Manual: Owner's Manual P/N 6A8WWNM-2-20
(INSTALLATION MANUAL, MAINTENANCE MANUAL AND
ILLUSTRATED PARTS BREAKDOWN)

TR-2023-003: 29 August 2023

Owner's Manual
for IFEEL ENTERTAINMENT SYSTEM INSTALLATION
P/N 6AB1AD016-001

Appendix W to
6AB1WNM-2-20

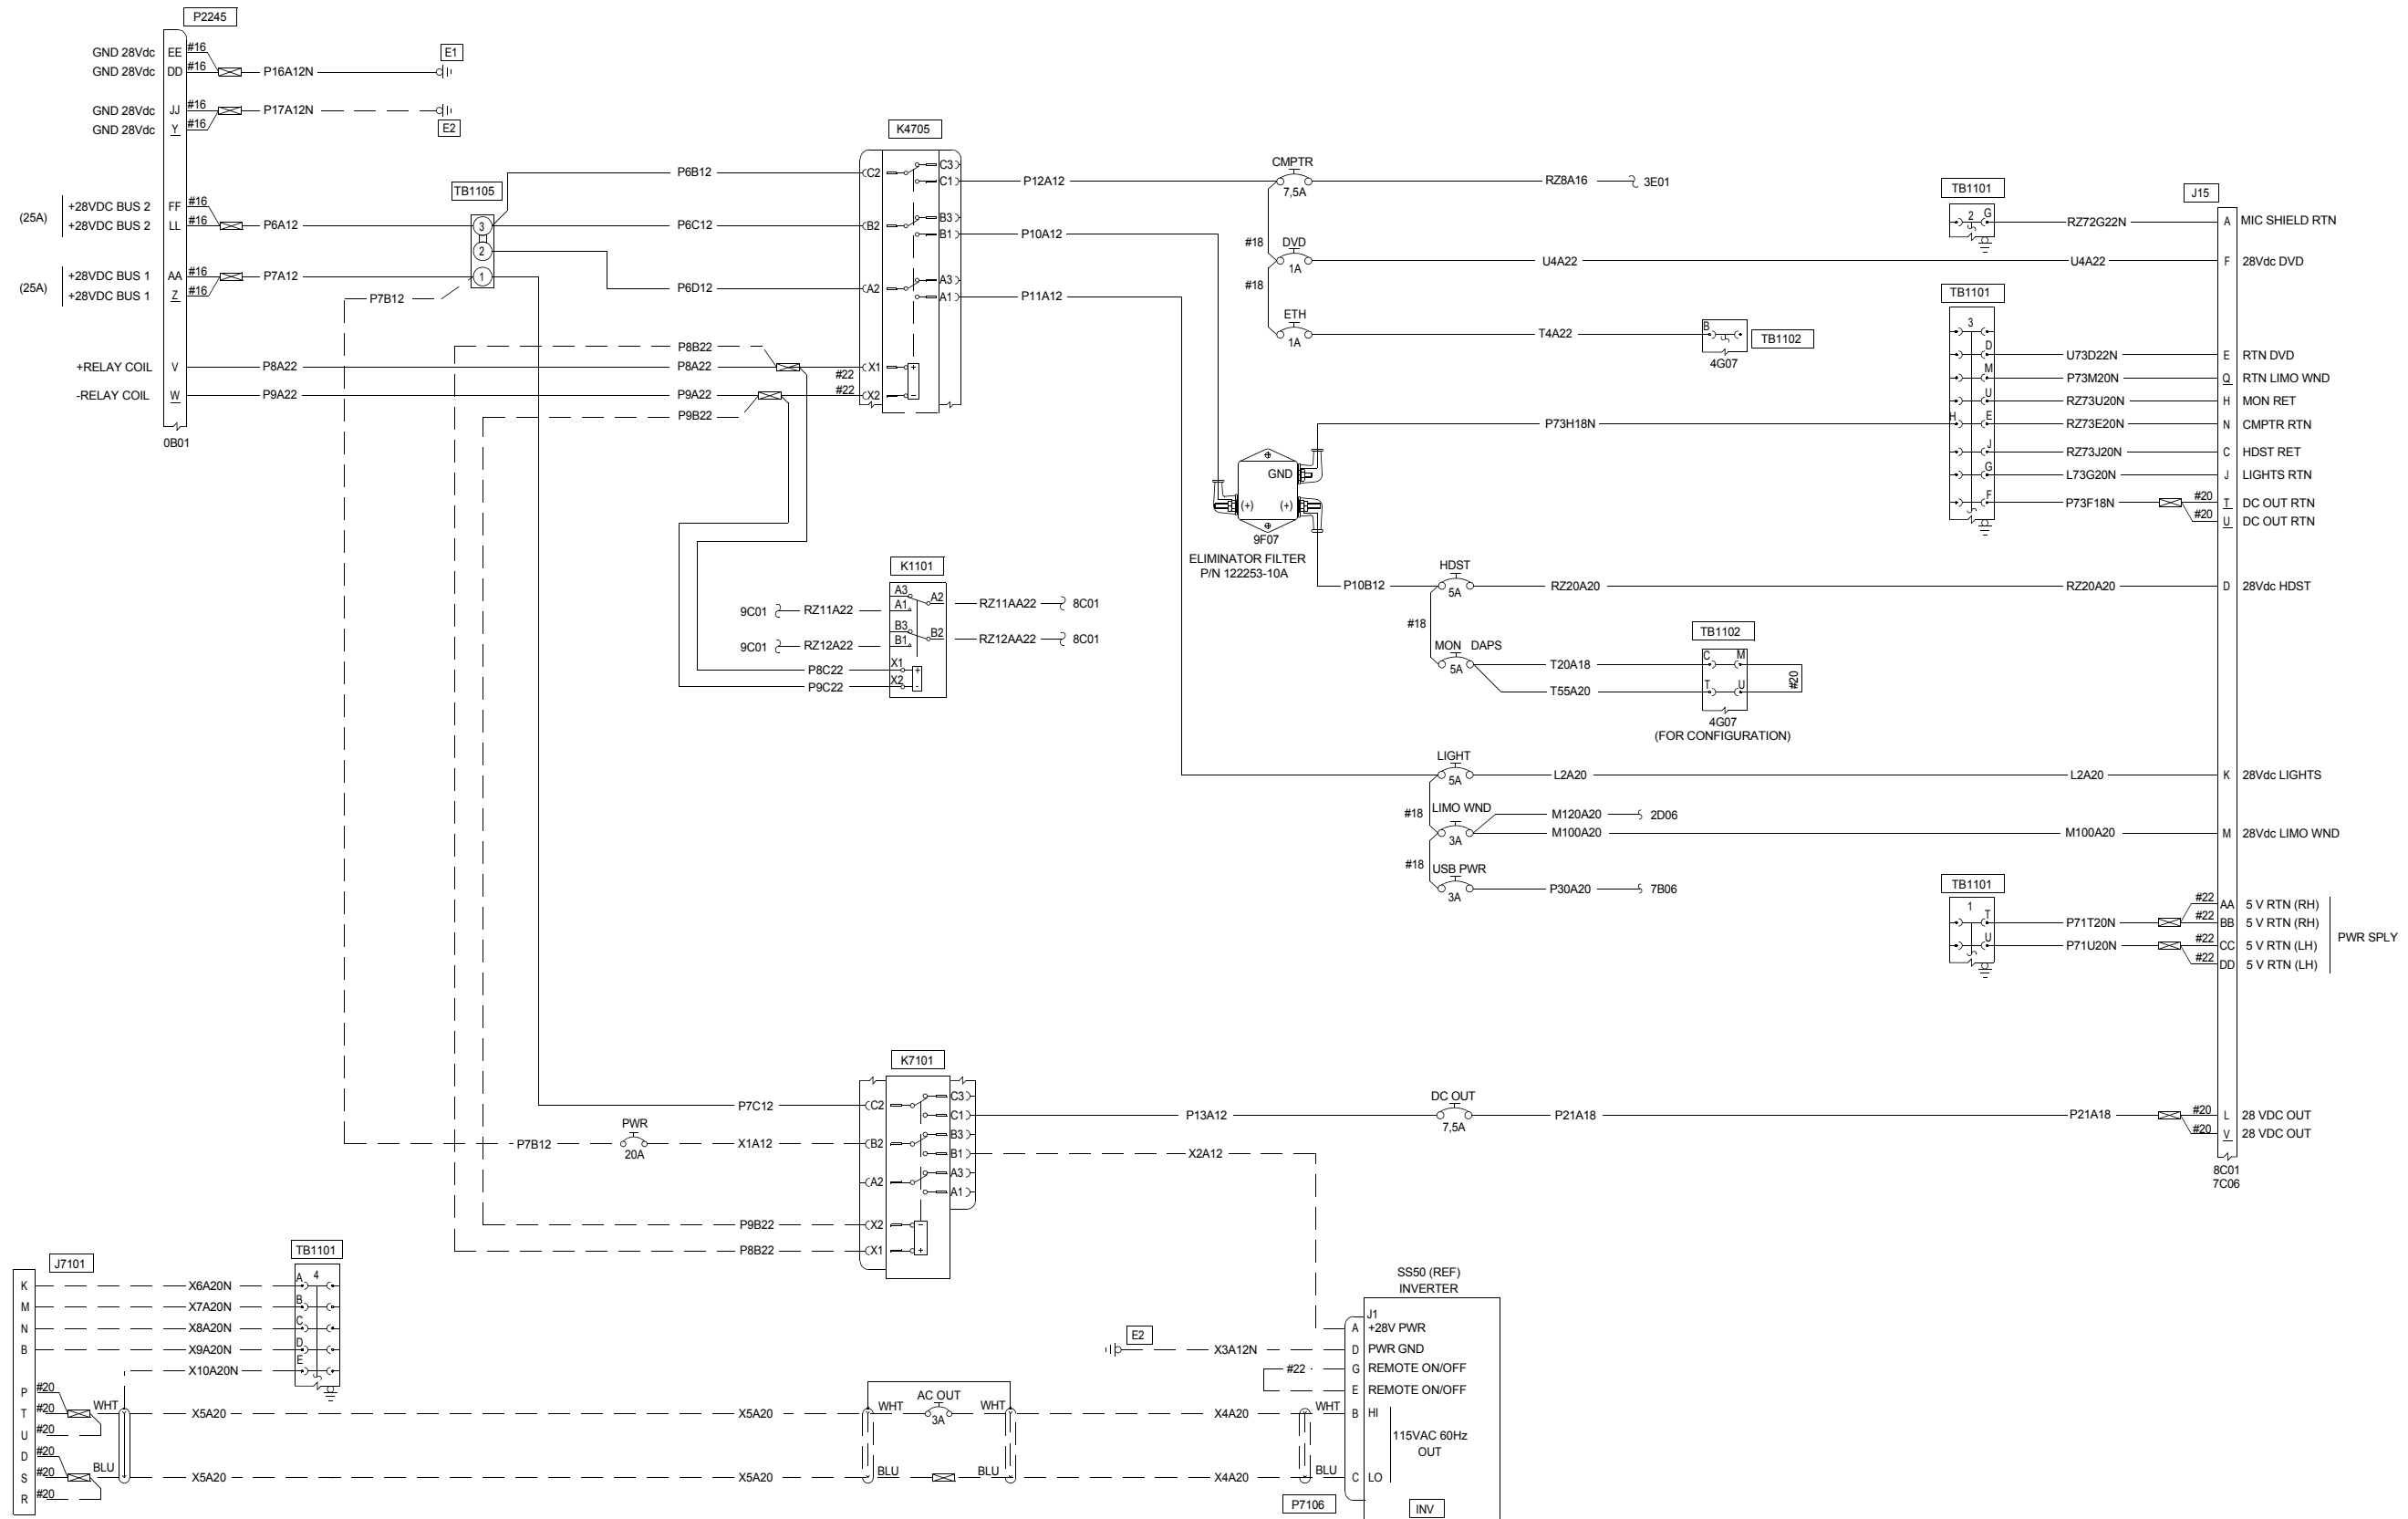
NOTE: this figure is NOT applicable when Touch screen Retromod (31493) P/N 6AB1EL339-001 is installed. Refer to Figure 5-5 of this Appendix

Figure 5-1 Rack wiring diagram (Sheet 2 of 2).

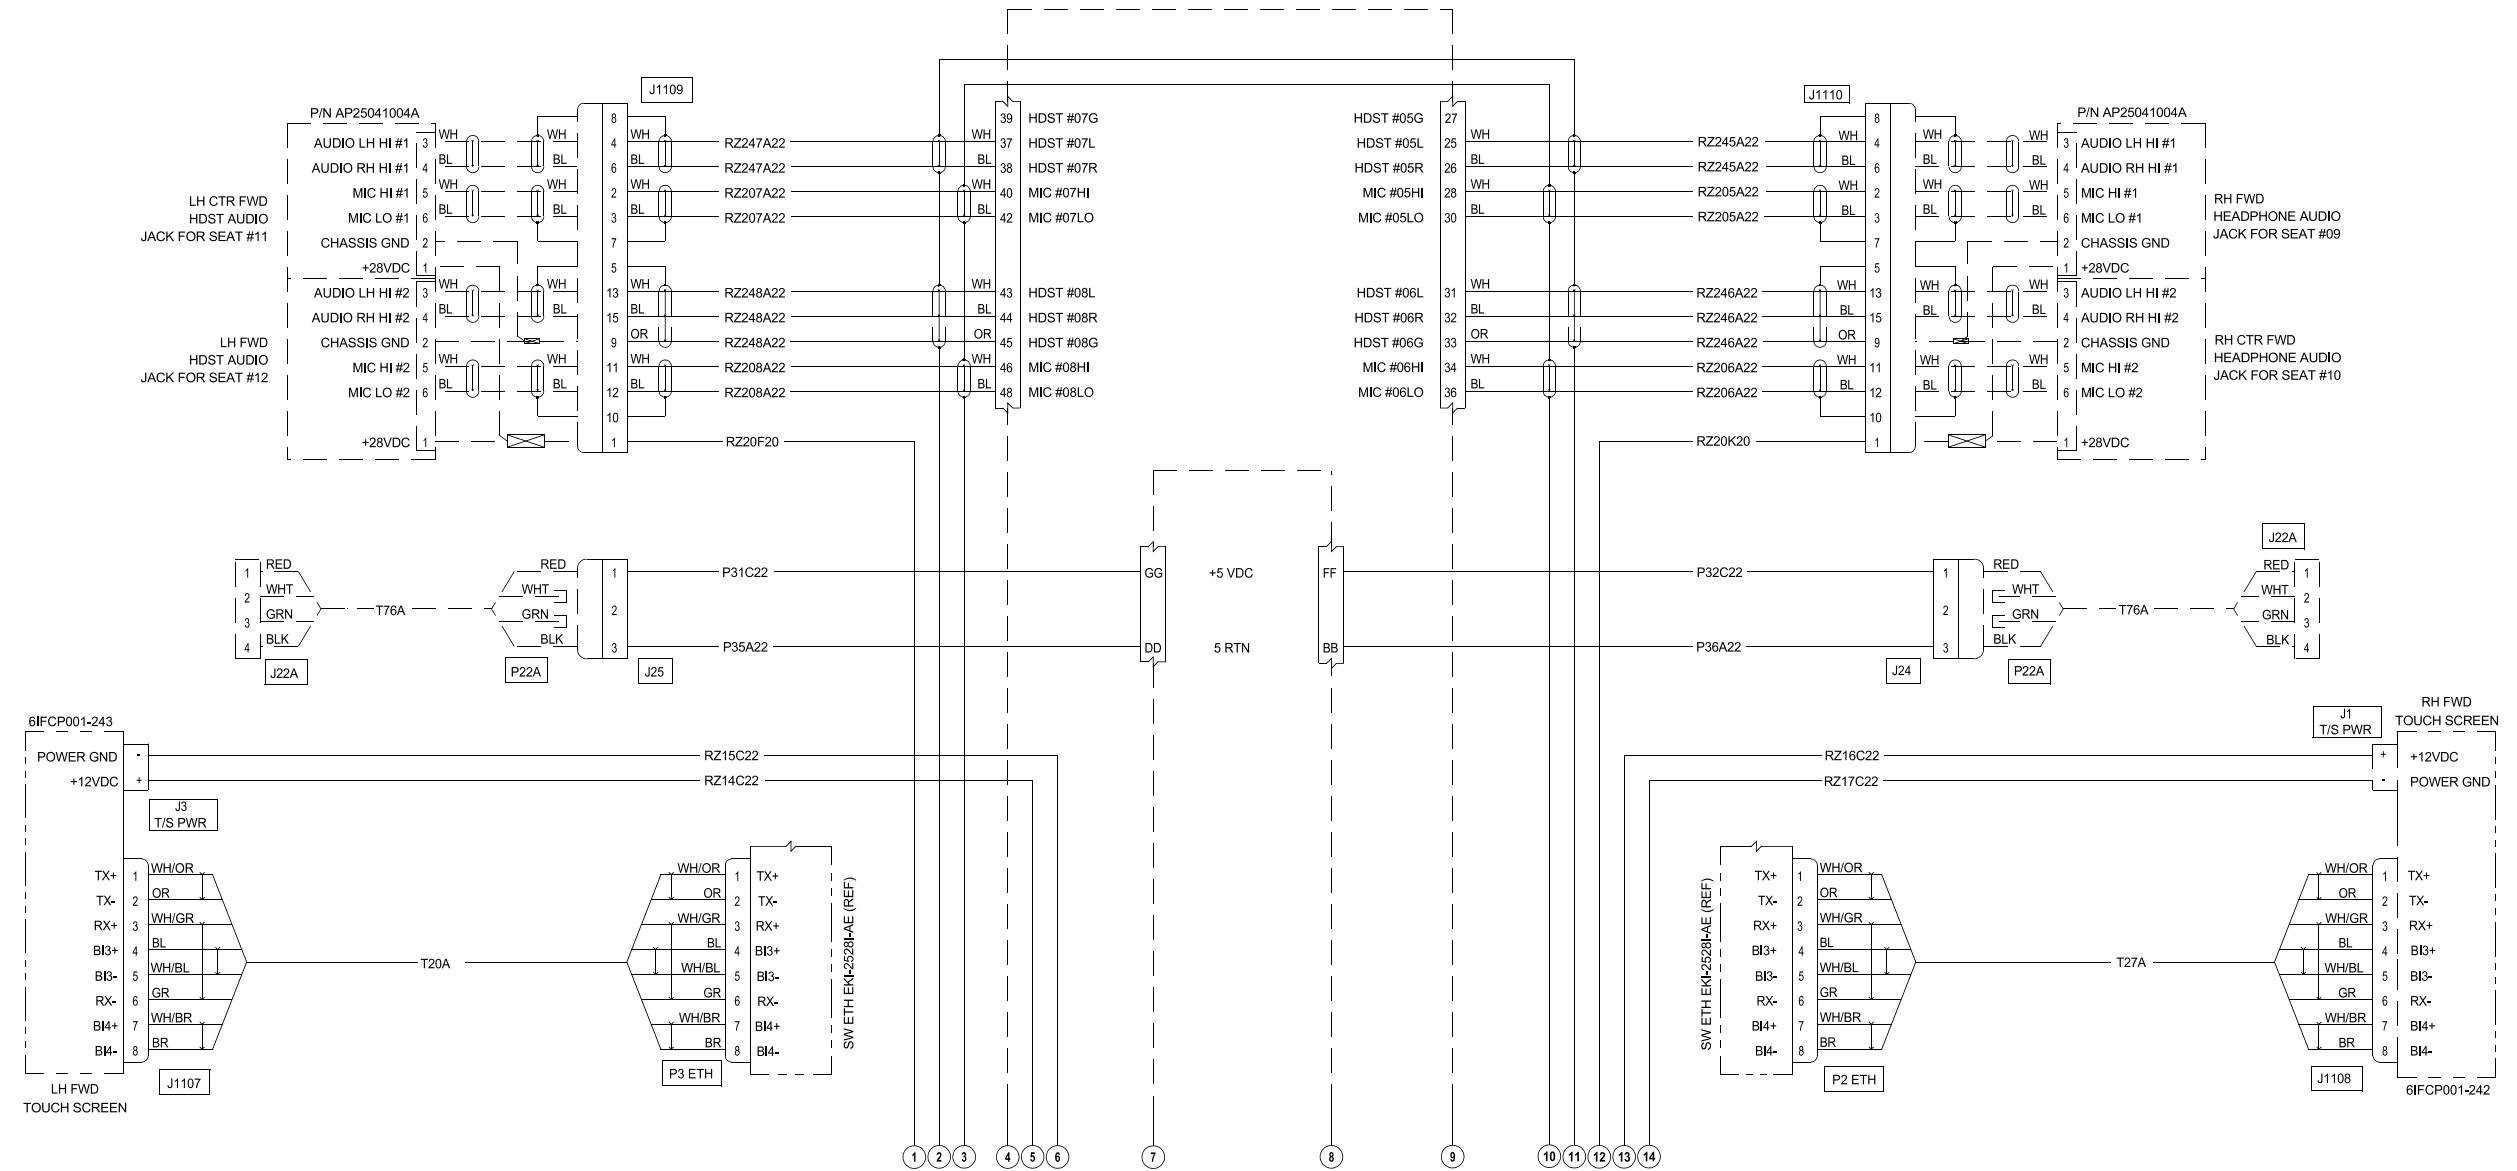
NOTE: When Touch screen Retromod (31493) P/N 6AB1EL339-001 is installed, P/N 6IFCP001-242 or -243 or -244 or -245 are replaced by P/N 6IFCP-UNI-001.

Figure 5-5 Touch screen Retromod (31493)

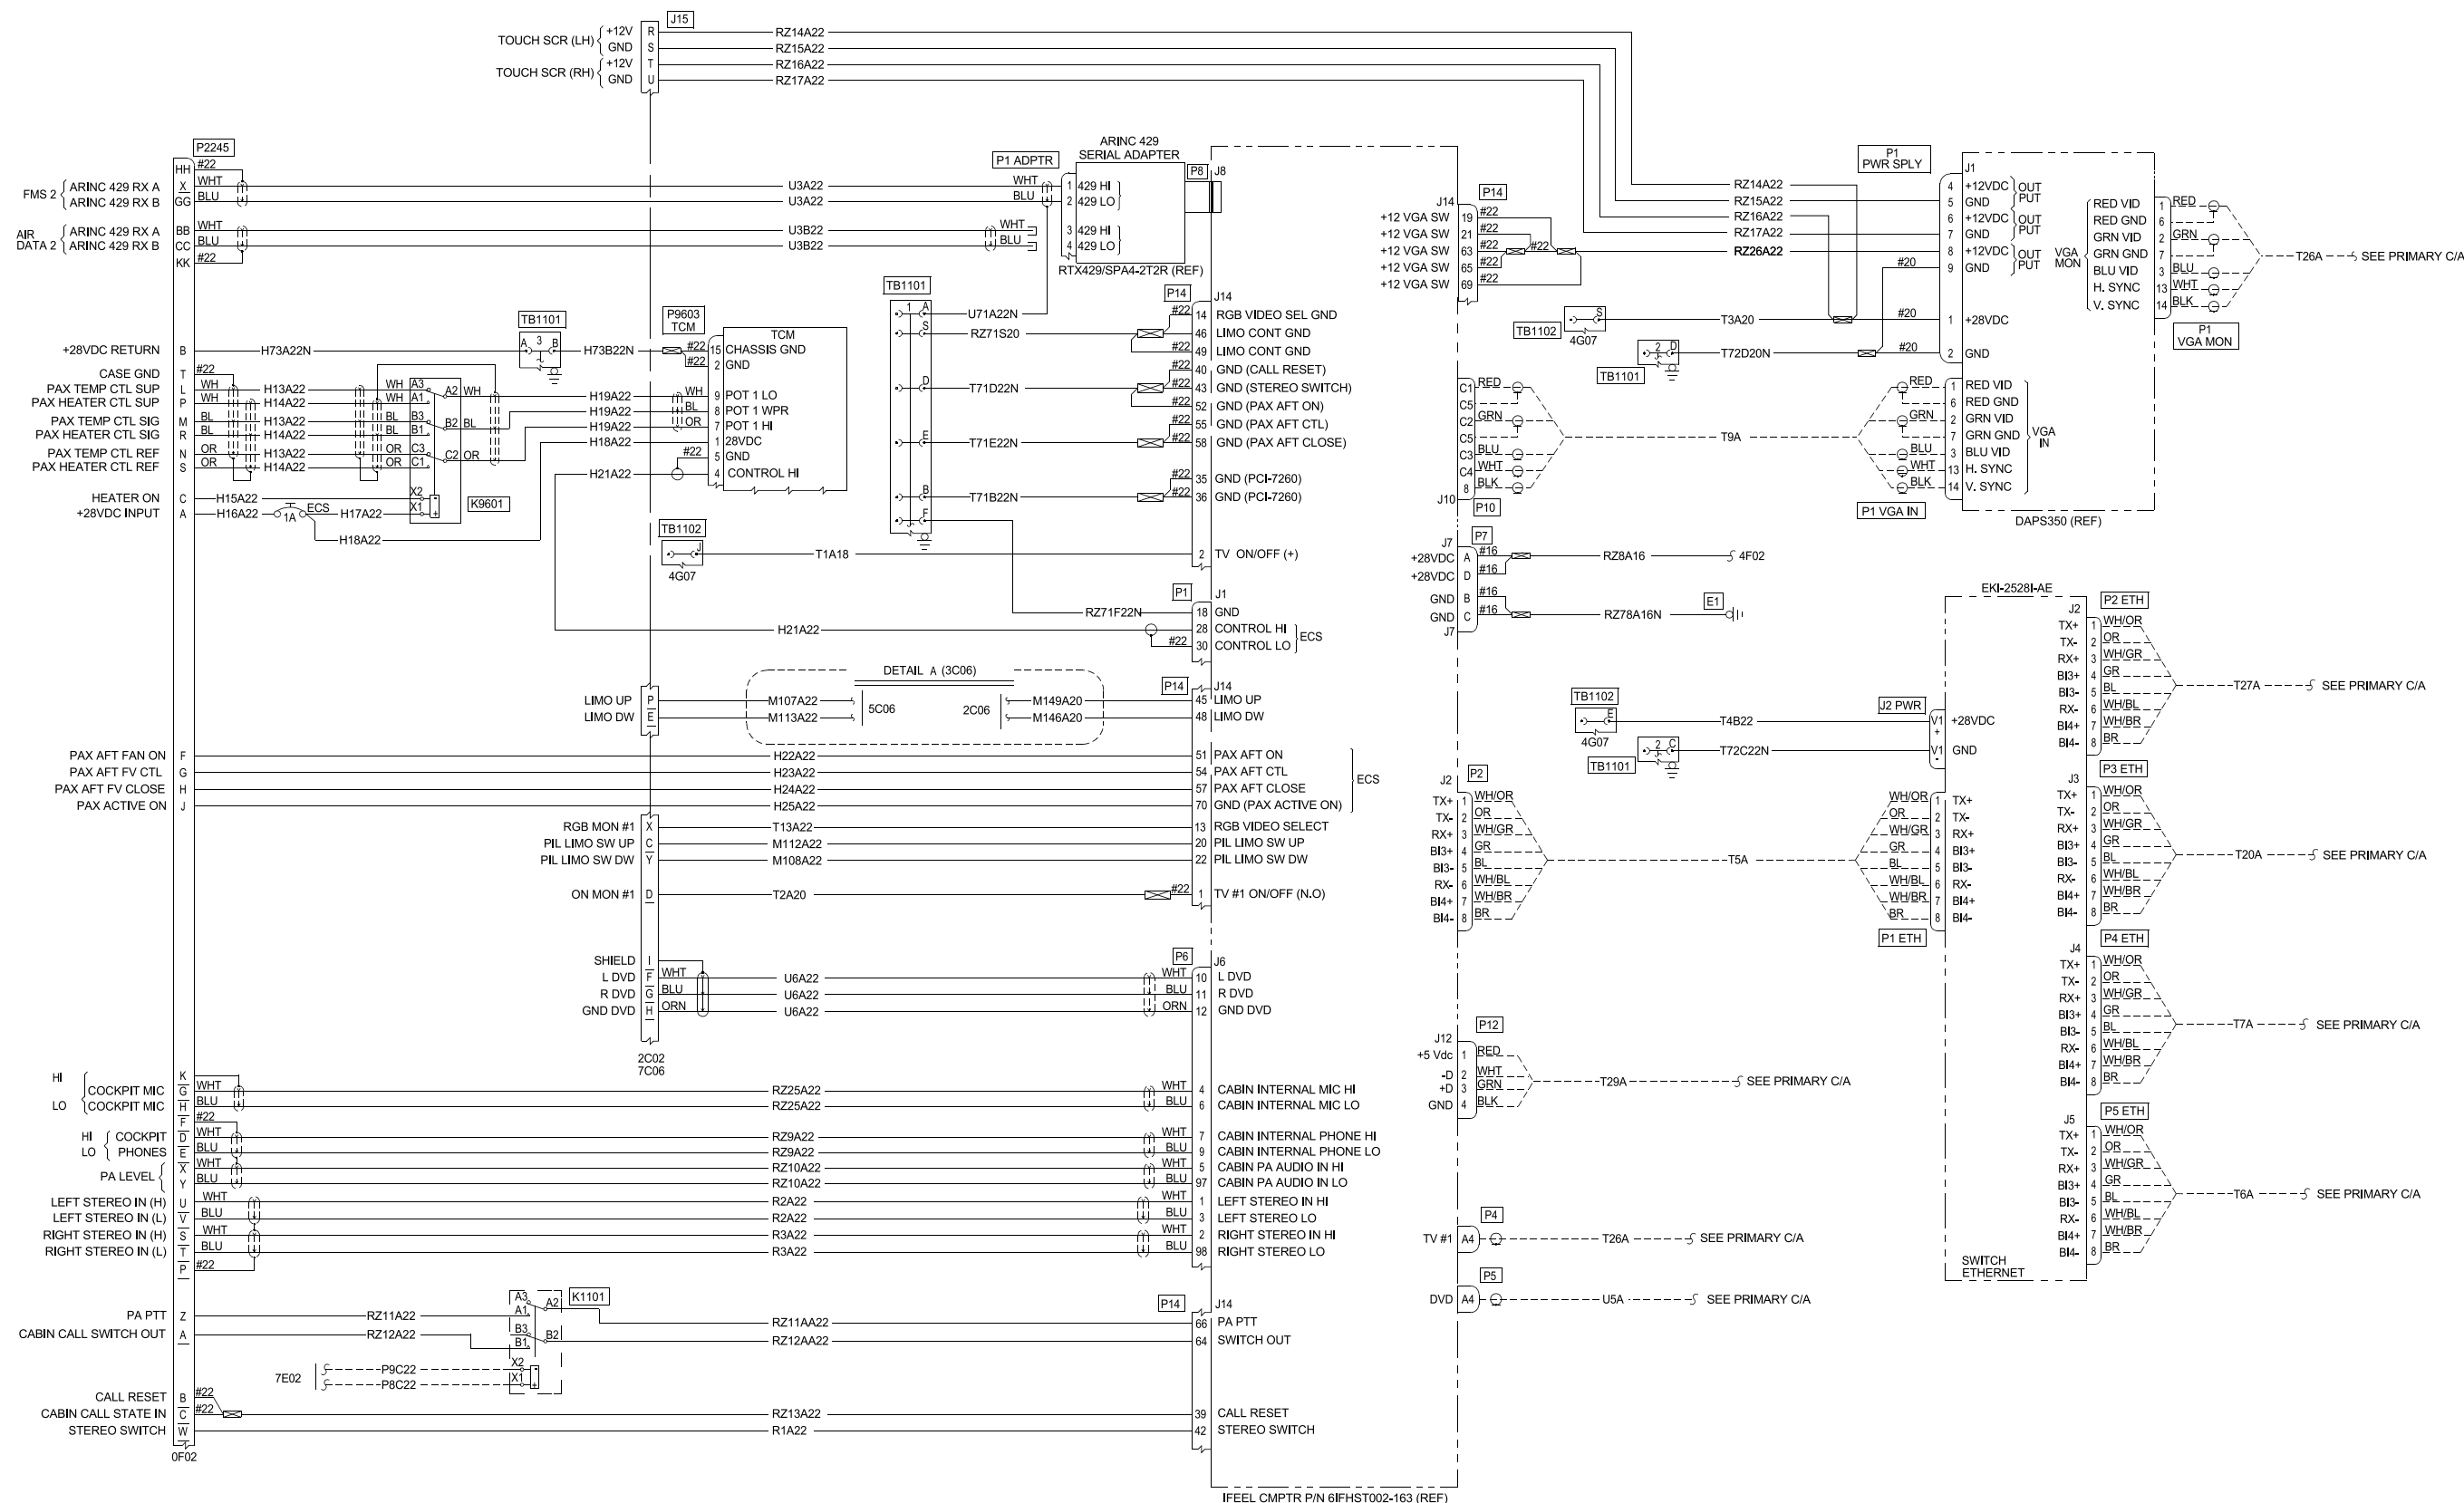
3. Gain access to the equipment rack assy.
4. Making reference to the applicable Wiring Diagram disconnect P1 PWR SPLY connector from VGA splitter DAPS350 and rework wiring in order to power touch screen with 28 Vdc current, as follows:

- a. Making reference to the applicable Wiring Diagram, on connector P1 PWR SPLY:
 - i. Disconnect cable T3A20 from pin 1 ;
 - ii. Disconnect cable RZ14A22 from pin 4;

- iii. Disconnect cable RZ16A22 from pin 6;
 - b. Making reference to Figure 5-5 of Wiring Diagrams section of this Appendix, on connector P1 PWR SPLY:

- i. Splice together wires T3A20, RZ14A22, RZ16A22 and a wire AWG #20 unmarked.
 - ii. Crimp a Pin P/N M39029/63-368 on AWG #20 unmarked cable;
 - iii. Connect AWG #20 unmarked cable to Pin 1;

- iv. Leave Pin a and Pin 6 of P1 PWR SPLY unconnected.
5. Connect P1 PWR SPLY connector to VGA splitter DAPS350.
